Access Compliance Report Public Rights-of-Way (Curb Ramps)

Main Street: FALABELLA_DR Cross Street: SYLVANOAK_WAY Location: SE

ADA ID: RPRK211112150202 Ramp Type: Type 1 - Perpendicular Initial Pass/Fail: Pass Overall Compliance: No Severity Score: 15

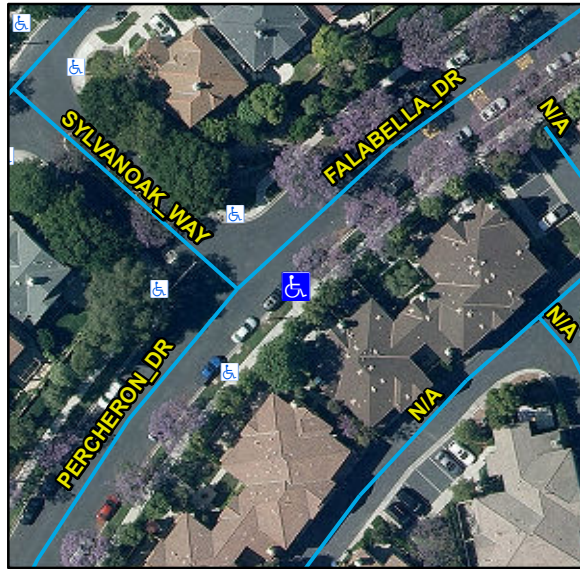
Compliance	Description	Data	Compliance	Description	Data
N/A	Ramp Length (in)	77	N/A	Flare Type LT	
Yes	Ramp Width (in)	48			Sloped
Yes	Ramp Run Slope (%)	7.8	N/A	Flare Slope LT (%)	12
Yes	Ramp Cross Slope (%)	2	N/A	Flare Traversable LT	No
N/A	Landing Present	Yes	N/A	Flare Type RT	
N/A	Landing Length (in)	60			Sloped
Yes	Landing Width (in)	48	N/A	Flare Slope RT (%)	10.5
No	Landing Run Slope (%)	2.1	N/A	Flare Traversable RT	No
Yes	Landing Cross Slope (%)	0.6	No	DWS Provided	No
N/A	Landing Movement Obstructed?	No	N/A	DWS Contrast	N/A
	Landing Movement Type	N/A	N/A	DWS Length (in)	N/A
N/A	Landing Shared	No	N/A	DWS Full Width	N/A
N/A	Clear Space	N/A	N/A	DWS Offset Left (in)	N/A
N/A	Clear Space To Crosswalk (in)	N/A	N/A	DWS Offset Right (in)	N/A
N/A	Marked Crosswalk 1	No	N/A	Marked Crosswalk 2	N/A
	Crossing 1 Direction	N		Crossing 2 Direction	N/A
	Marked Crosswalk 1 Width (in)	N/A		Marked Crosswalk 2 Width (in)	N/A

N/A	Ramp Inside Crosswalk 1	N/A	Yes	Ramp Inside Crosswalk 2	N/A
	Crossing 1 Slope (%)	1.8		Crossing 2 Slope (%)	N/A
	Crossing 1 Cross Slope (%)	2.5		Crossing 2 Cross Slope (%)	N/A
Yes	Gutter Ponding	No	Yes	Curb Slope	1.4
Yes	Gutter Lip Height (in)	0		Road Run Slope (%)	N/A
No	Gutter Run Slope (%)	9.1		Road Cross Slope (%)	N/A
No	Gutter Cross Slope (%)	2.8			
Yes	Overall Surface Condition: Acceptable		Yes	Perp Joint Present	Yes
	Cross Gutter Present?	No		Spandrel Present?	No
	Replace Cross Gutter?	N/A		Replace Spandrel?	N/A

Remove & Replace Entire Ramp. Remove & Replace Gutter.
